Site Plan and Design Review Staff Report and Recommendation

REPORT DATE:	June 12, 2017
HEARING DATE:	June 19, 2017
LAND USE REQUEST:	Site plan approval and design review of Stonewood Center, a proposed commercial and office complex consisting of four buildings totaling 45,280-square-feet, a restaurant with drive-through, parking and landscaping
FILE NUMBER:	311-16-000197-PLNG
PROPERTY LOCATION:	3650 Pacific Avenue
LEGAL DESCRIPTION:	Washington County Tax Lots 1S305AB00501 & 1S305AB00504
OWNER/APPLICANT(S):	<u>Applicant/Property Owner:</u> A. C. "Buzz" Avery, 27752 County Lane, Laguna Niguel, CA 92677 <u>Applicant's Representatives:</u> • Barry Newdelman Associates Architects, 2340 SE Tamarack Avenue, Portland, Oregon 97214 • Jeff Bolden, Multi-Tech Engineering Inc., 1155 13th Street SE, Salem, Oregon 97302
COMPREHENSIVE PLAN MAP AND ZONING MAP DESIGNATIONS:	Community Commercial (CC) Community Commercial (CC)
APPLICABLE STANDARDS AND CRITERIA:	City of Forest Grove Development Code ☐ §10.3.300 - .340 <i>Commercial and Mixed Use Zones</i> ☐ §10.7.200 et. seq. <i>Solid Waste and Recycling</i> ☐ §10.8.000 et. seq. <i>General Development Standards</i> City of Forest Grove Design Guideli

LANDSCAPE PLAN

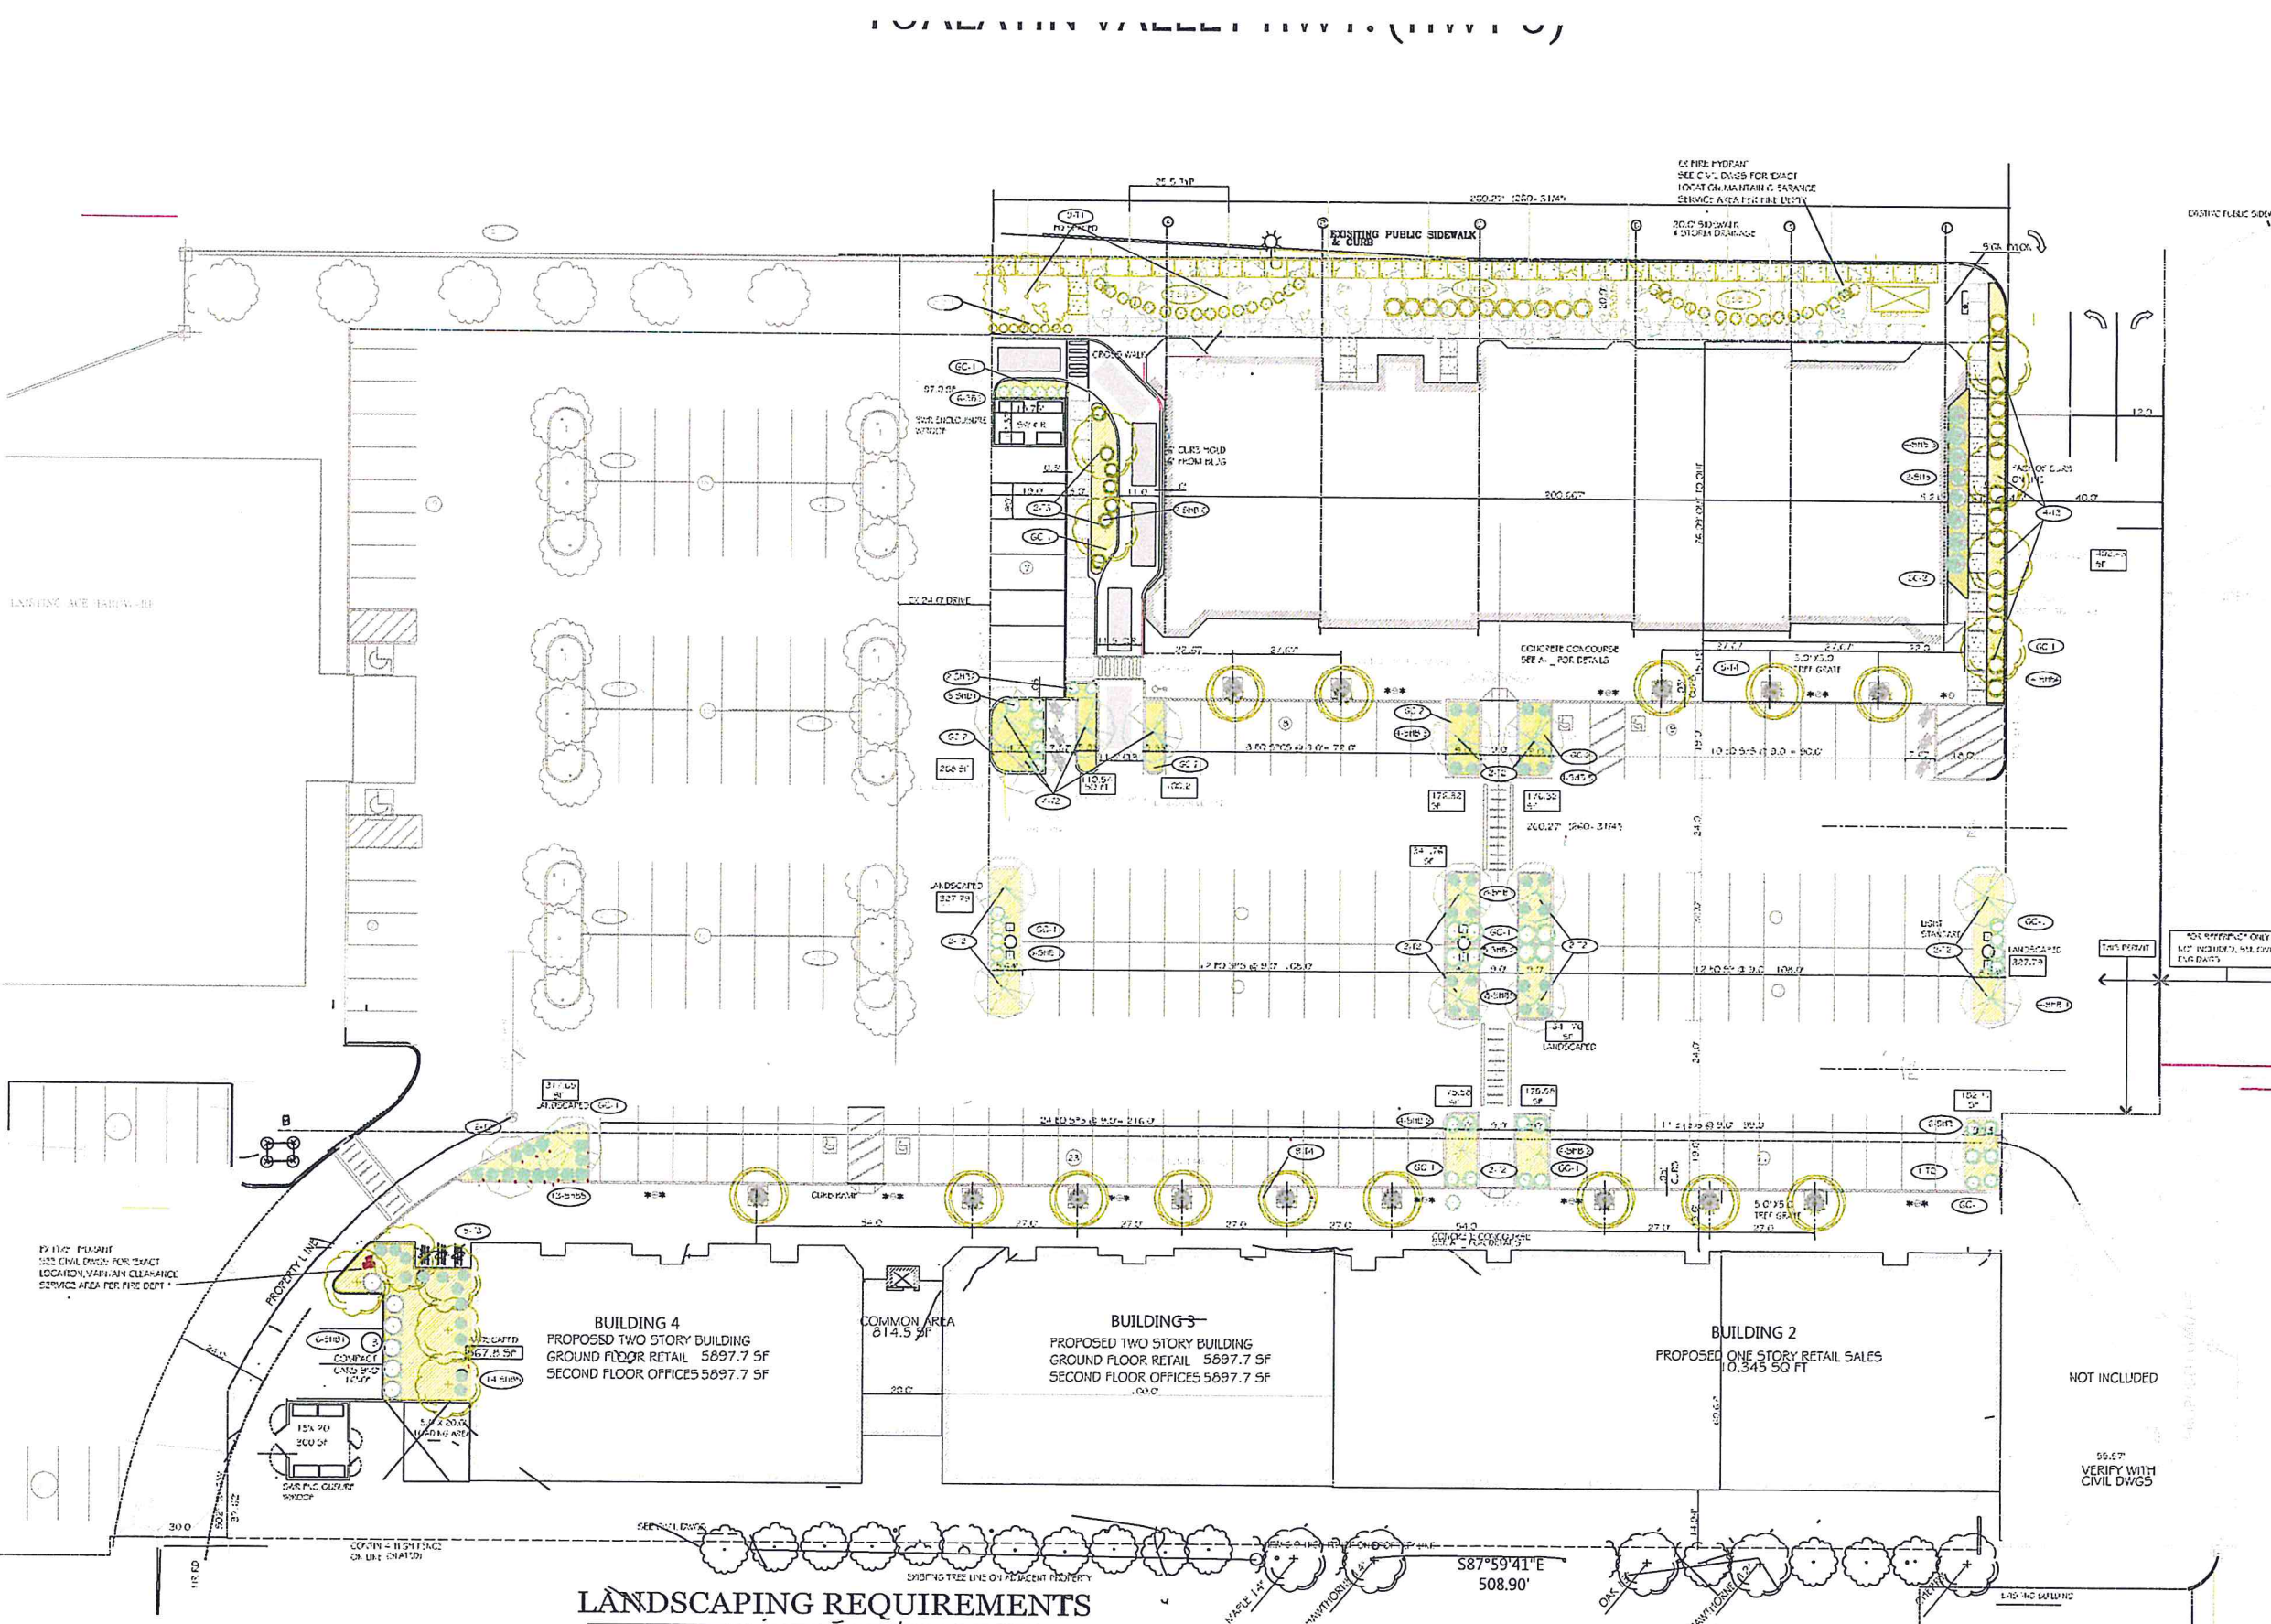
- c. Sourwood trees are proposed in place of several of the Sargent cherry trees included in the original landscape plan. Sourwood trees grow to a height of 25-30 feet, with a 20-foot-wide spread. Nineteen sourwoods are proposed in and around the car park (identified as T2 on the landscape plan). Staff believes these trees are spaced too closely together and would not achieve the desired dimensions. Furthermore, because of their limited spread (only 20 feet) they would offer virtually no car park shade. Staff is therefore recommending these **conditions**:

- i. The landscape plan shall be revised to include large canopy trees (examples include several varieties of maple, oak, elm and zelkova).
 - ii. Large canopy trees shall be dispersed around the car park in order to provide maximum shade.

- iii. Two additional landscape islands with an east-west orientation shall be included in the central parking area, one each between the pedestrian walkway and the east and west landscape islands. To provide a sufficient

17. The landscape plan shall be revised to include large canopy trees (examples include several varieties of maple, oak, elm and zelkova).
18. Large canopy trees shall be dispersed around the car park in order to provide maximum shade.

19. Two additional landscape islands shall be included in the central parking area, one each between the pedestrian walkway and the east and west landscape islands. To provide a sufficient root zone for large canopy trees, the two additional islands shall have a minimum length of 16 feet and a minimum width of 6 feet.

21. Four of the sourwood trees proposed in the central landscape islands shall be replaced with large canopy trees, one in each island.
22. Revisions to the landscape plan shall be reviewed and approved by City staff prior to installation.
